CASE: UM 1910/1911/1912
WITNESS: BRITTANY ANDRUS

**PUBLIC UTILITY COMMISSION
OF
OREGON**

STAFF EXHIBIT 100

March 16, 2018

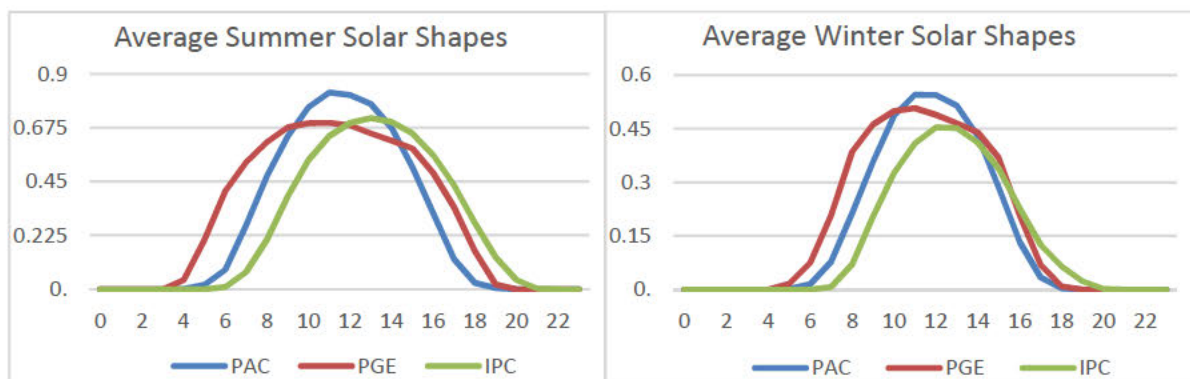
1 **Q. What are the results of applying the three utilities' hourly shaping**
 2 **methods to monthly energy prices?**

3 A. Staff provides quarterly comparisons of each utility's results in the four
 4 graphs below.
